**SUBJECT: ORDER FOR MODIFICATION OF LICENSES CONCERNING PRIMARY COOLANT
SYSTEM PRESSURE ISOLATION VALVES**

ORDER FOR MODIFICATION OF LICENSES

SAFETY EVALUATION REPORT
TURKEY POINT PLANT, UNIT NOS. 3 AND 4
PRIMARY COOLANT SYSTEM PRESSURE ISOLATION VALVES
(WASH-1400, EVENT V)

**PRIMARY COOLANT SYSTEM
PRESSURE ISOLATION VALVES**FLORIDA POWER & LIGHT COMPANY
TURKEY POINT UNITS 3 AND 4

Figure 1. Valve Configurations Designated by the NRC To Be Included in This Technical Evaluation

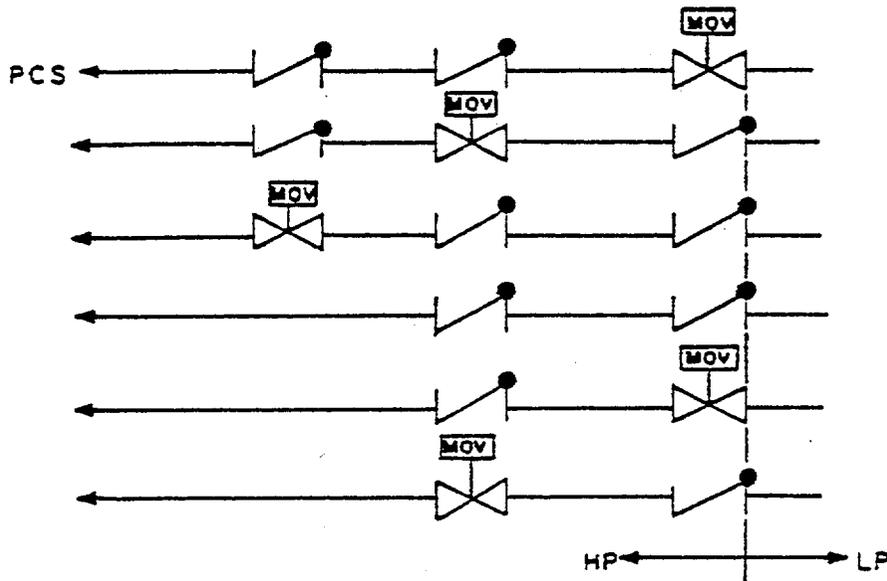
For a piping system to have a valve configuration of concern, the following five items must be fulfilled:

- 1) The high-pressure system must be connected to the Primary Coolant System;
- 2) there must be a high-pressure/low-pressure interface present in the line;
- 3) this same piping must eventually lead outside containment;
- 4) the line must have one of the valve configurations shown in Figure 1; and
- 5) the pipe line must have a diameter greater than 1 inch.
